Piper Aircraft Corporation  
Vero Beach, Florida, U.S.A.

# SERVICE No. 910A BULLETIN

Date October 10, 1989 S

SUBJECT: Wing Lift Strut Assembly  
Inspection/Replacement

**SKETCH "A"**

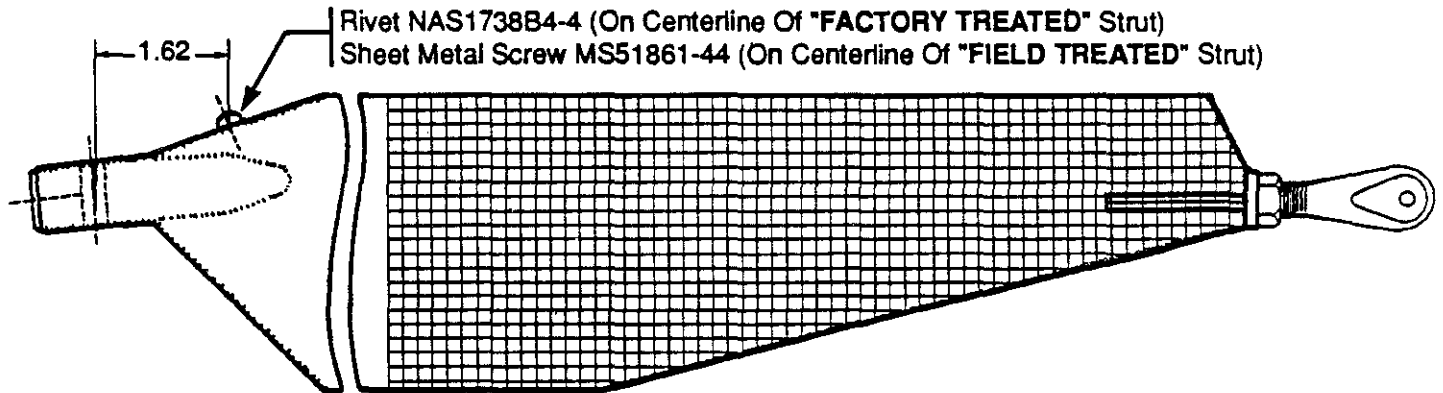
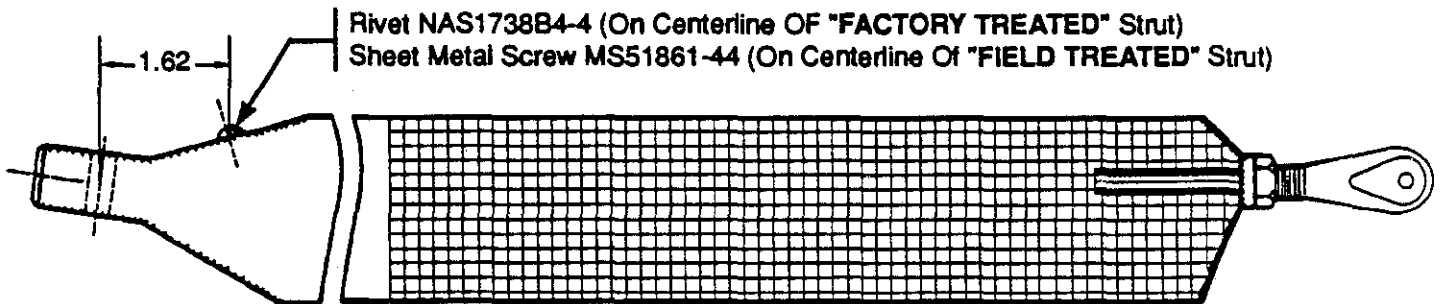
1. Remove wing lift struts and accomplish the inspection per inspection procedures on Sketch "A". Caution: All aircraft utilizing "cuffs" at the wing lift strut roots (top and/or bottom) should take extra care in inspection for external corrosion in the areas covered by the cuffs.

5. Treat (corrosion impediment) each wing lift strut per the instruction procedure note on Sketch "A". Treatment must coincide with each inspection as outlined in the compliance time above.

1. Securely tape a sheet of thin 1/4 inch graph paper to the lower 11 inches of the top and bottom surface on all wing lift struts.
2. Using a Maule "Fabric Tester" and holding tool normal to strut contour, apply pressure at a scale reading of 80 in each of the grid blocks.
3. Remove the paper and inspect the lift strut tubes. A perceptible dent will appear if internal corrosion is present. If any dents are found, be certain the dent are in the metal by carefully removing the paint.
  - a. Lift strut tubes indicating the presence of any perceptible dent in the metal must be replaced with a new lift strut assembly before further flight.
  - b. If no dents appear in the metal, the lift strut may be considered airworthy.

- a. Remove lift strut from aircraft.
  - b. Inject one quart of Valoil, Lionoil Multi-Purpose L-1, Linseed Oil, Paraketone or any alternate preservative conforming to Federal Specification TT-S-176D, into the bolt hole at the top of the strut.
  - c. Plug the bolt holes and slosh oil until interior of strut is thoroughly coated.
  - d. Drain oil from strut (through bolt holes) and install MS51861-44 sheet metal screw, as shown, for future identification.
  - e. Reinstall strut to aircraft and rig.
4. Record lift strut inspection in aircraft logbook.
